**BASEBALL STADIUM IN THE  
DIRIDON/ARENA AREA**

**FINAL ENVIRONMENTAL IMPACT REPORT  
VOLUME III**

APPENDIX I: First Amendment to Environmental Impact  
Report (Response to Comments)

BASEBALL STADIUM IN  
THE DIRIDON/ARENA AREA  
ENVIRONMENTAL IMPACT REPORT

REBUILD SAN JOSE "A"  
FOR STRA'S BALL PARK  
OPTION - B

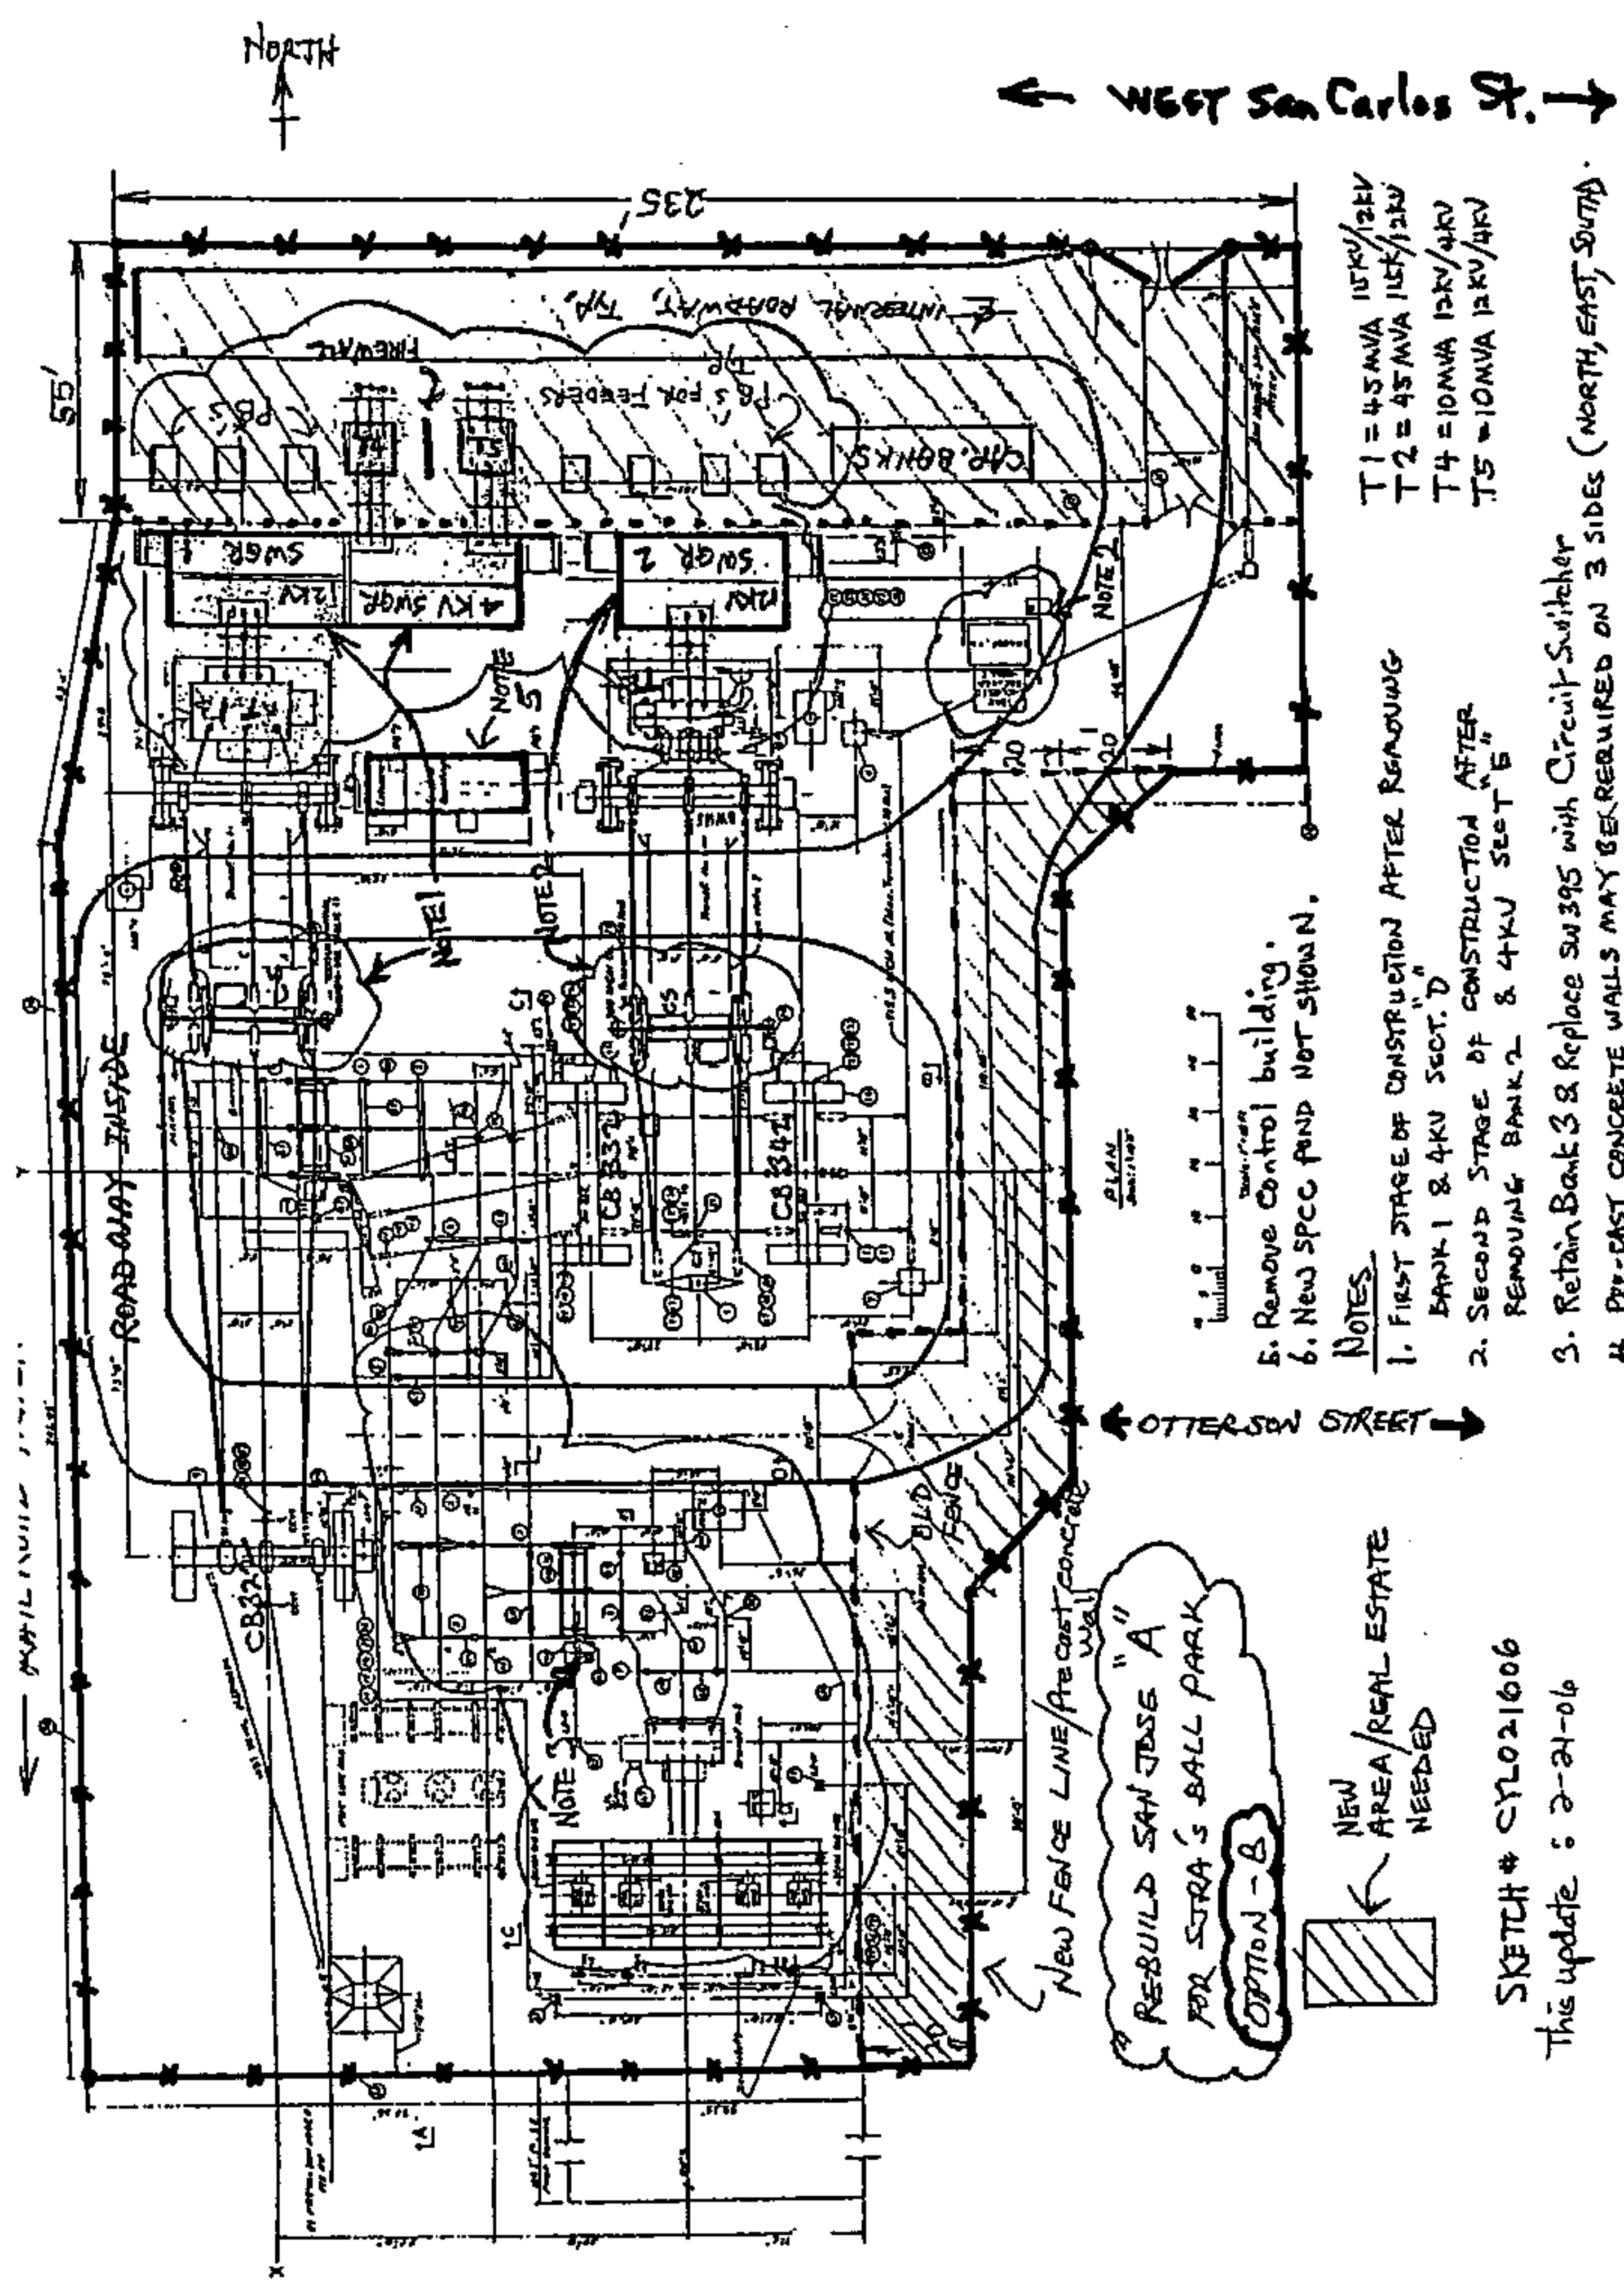
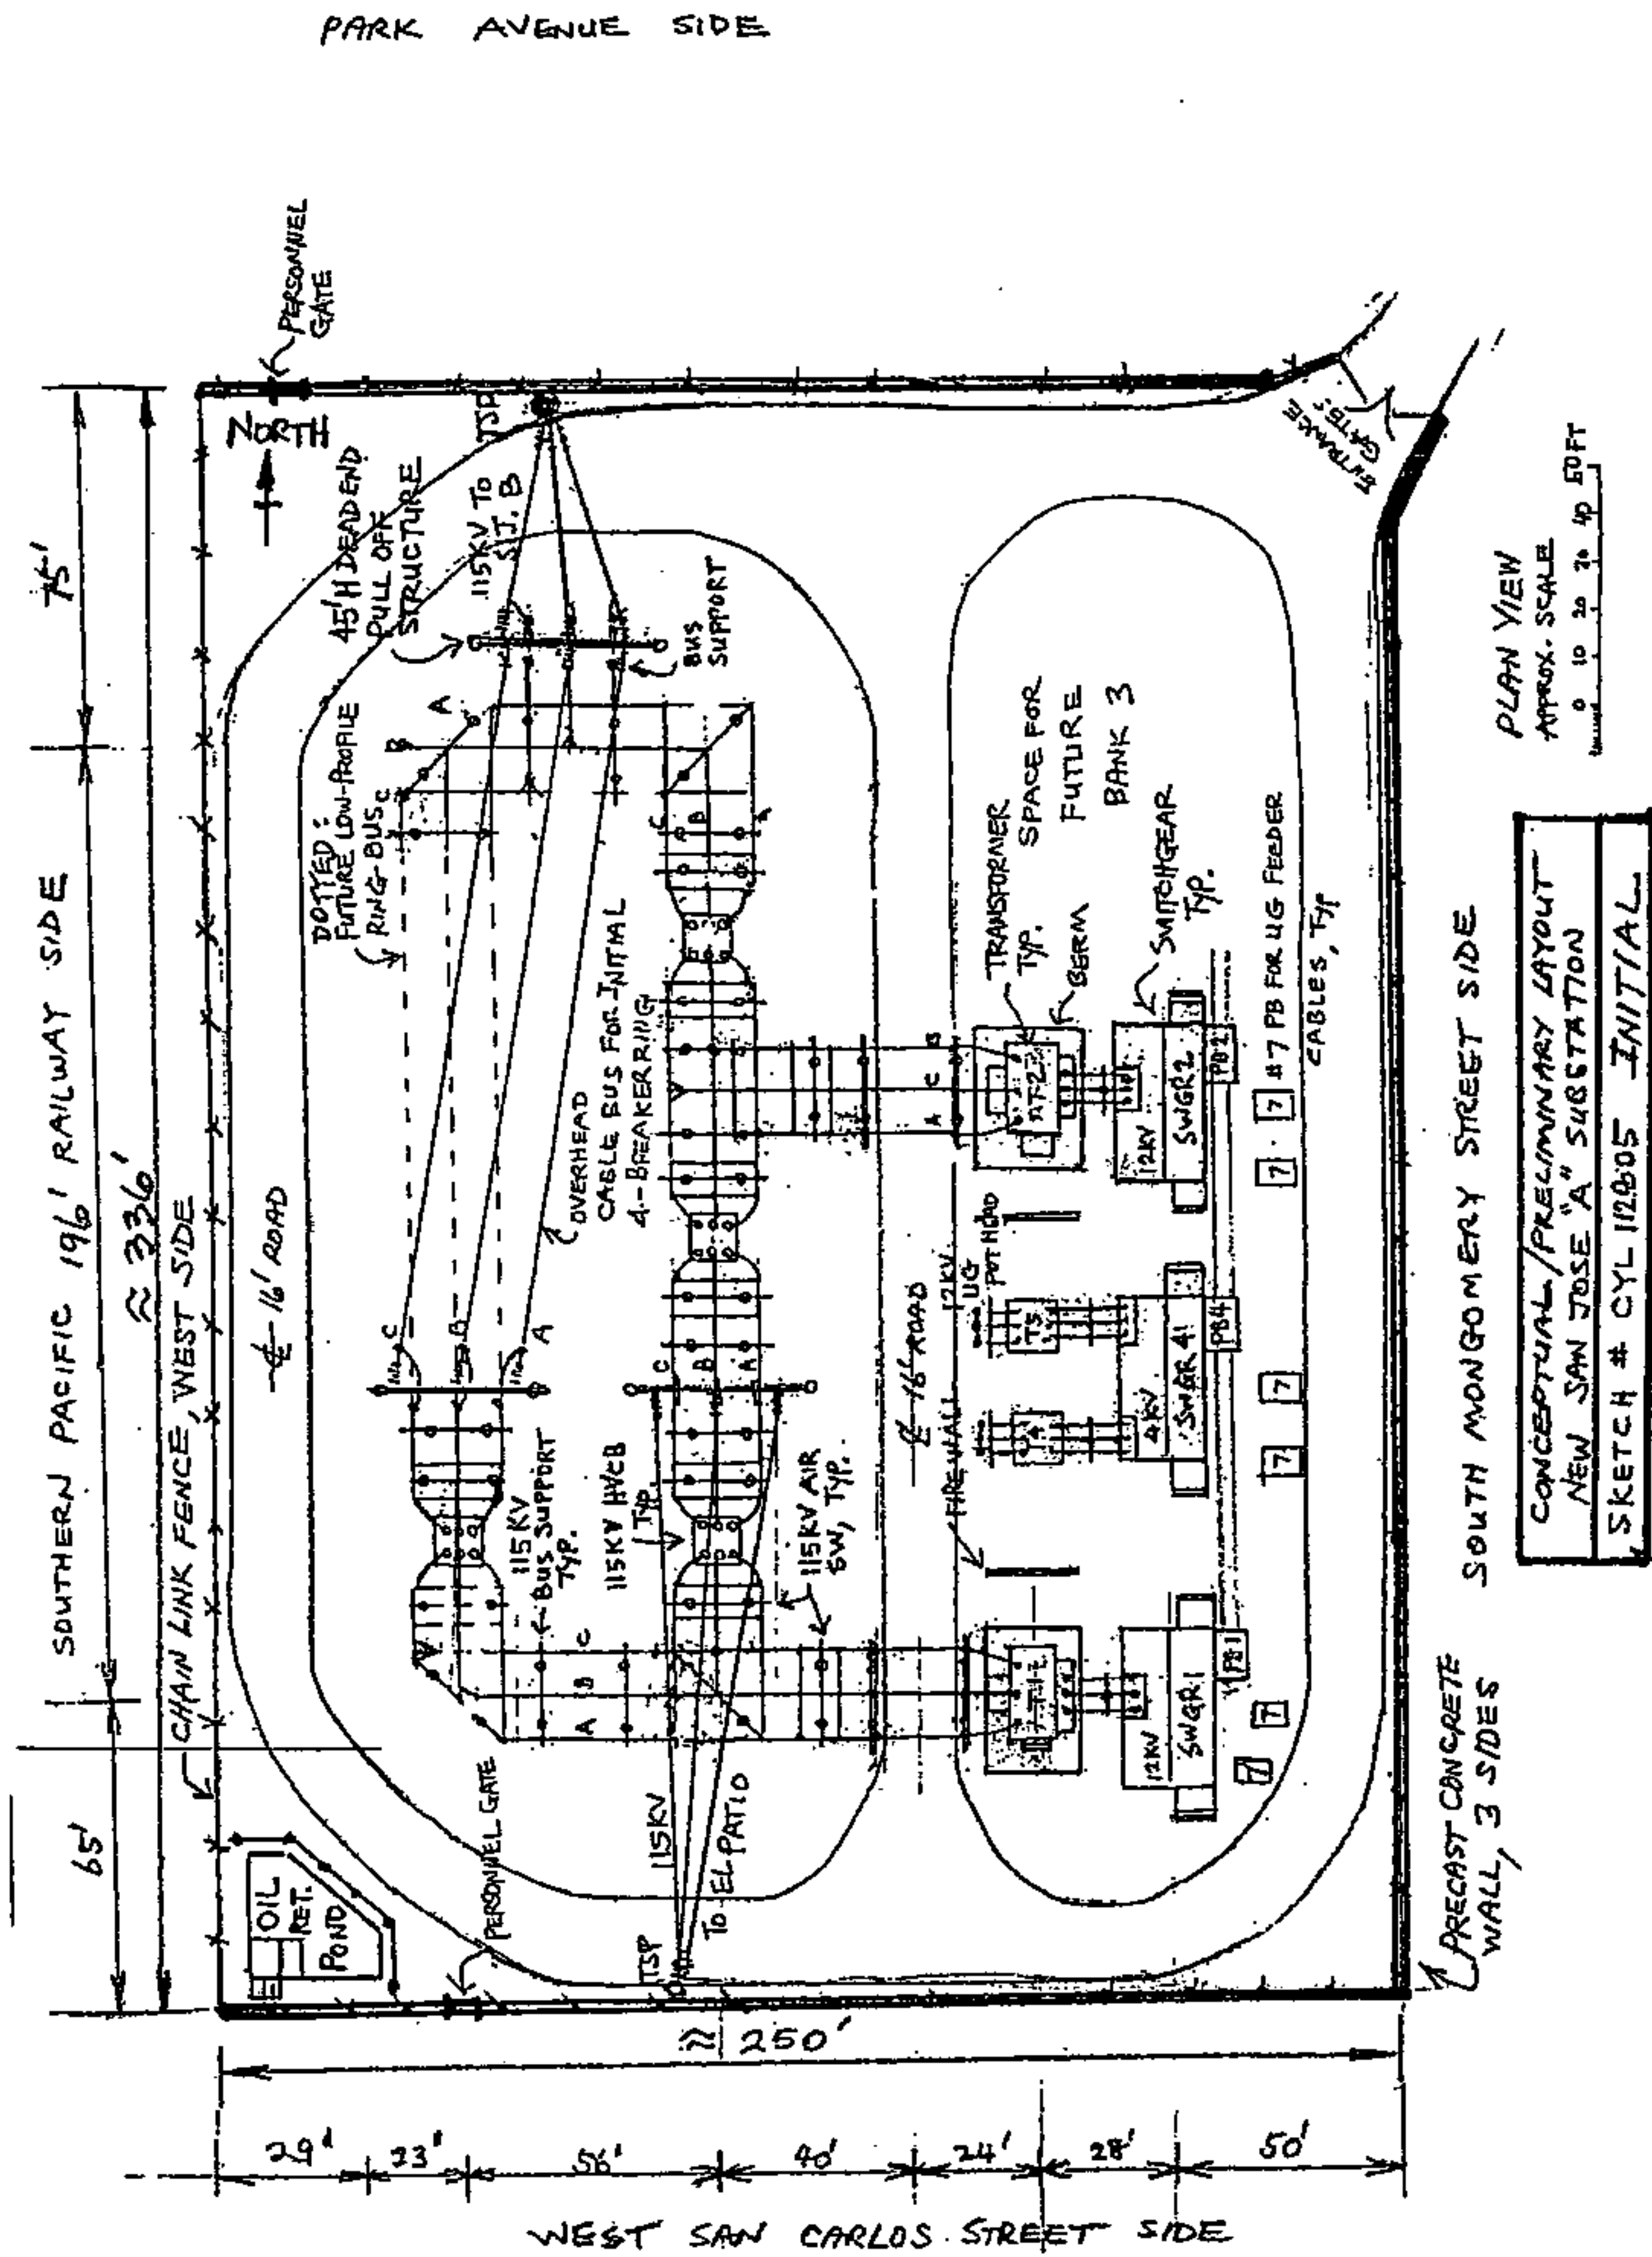
One general concern we have is that the DEIR is somewhat misleading on the final location of the substation. The Conceptual Site Plan (figure III-3) does not include PG&E facilities. The Project Description locates the ballpark in a position that assumes the substation will be relocated, and yet the PG&E Substation section assumes the substation will remain in place -- or be moved to a location south of the proposed garage that is too small to accommodate the substation. In fact, if the substation is relocated to the area indicated, the garage may need to be redesigned or eliminated.

First, the transmission lines going into and out of the Substation may require minor reconfiguration to accommodate the new Ballpark and relocated or reconfigured substation. Any reconfiguration will occur in the footprint outlined in Figure III-2 and Figure III-3 of the EIR. Second, fiber optic cables may have to be installed/rearranged to accommodate the substation relocation/reconfiguration project.

**C2-2:** A specific stadium design has not yet been developed for the proposed project. Figure III-3 of the Draft EIR shows the conceptual stadium orientation and design; this figure is an abstract of the potential stadium design, and is not meant to be a concrete depiction. Page 43 of the Draft EIR states that two options are being considered for the existing substation, either reconfiguration or relocation; both options are discussed in detail, to the extent that they are known.
